City of Mississauga Department Comments

Date Finalized: 2023-08-30 File(s): A281.23

The applicant requests the Committee to approve a minor variance to maintain the existing driveway width of 9.3m (approx. 30.51ft) whereas By-law 0225-2007, as amended, permits a maximum driveway width of 6.0m (approx. 19.68ft) in this instance.

Property Address: 3376 Colonial Drive

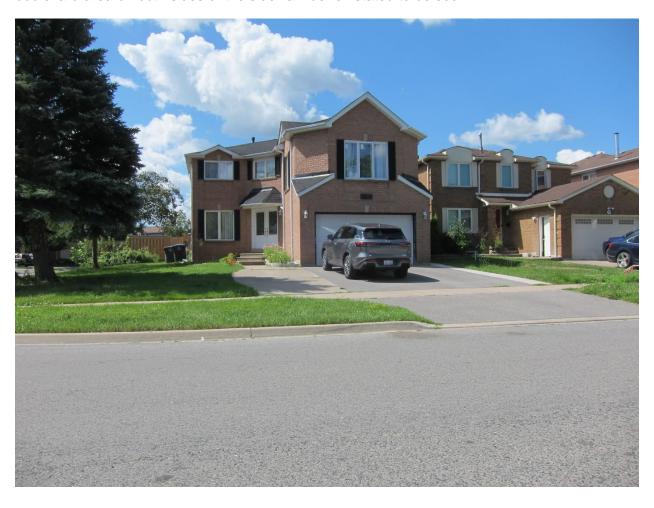
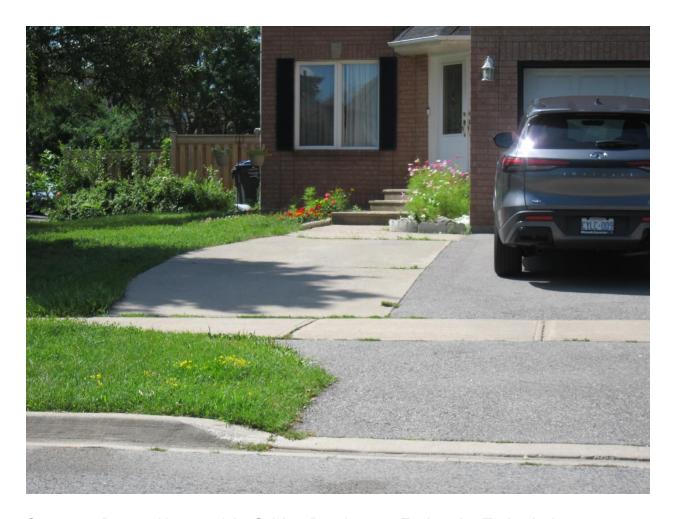
Enclosed are pictures of the existing driveway. The applicant has removed the sod within the Municipal boulevard and placed concrete and asphalt surfaces. We ask that the Municipal boulevard area on both sides of the sidewalk be reinstated to be sod.
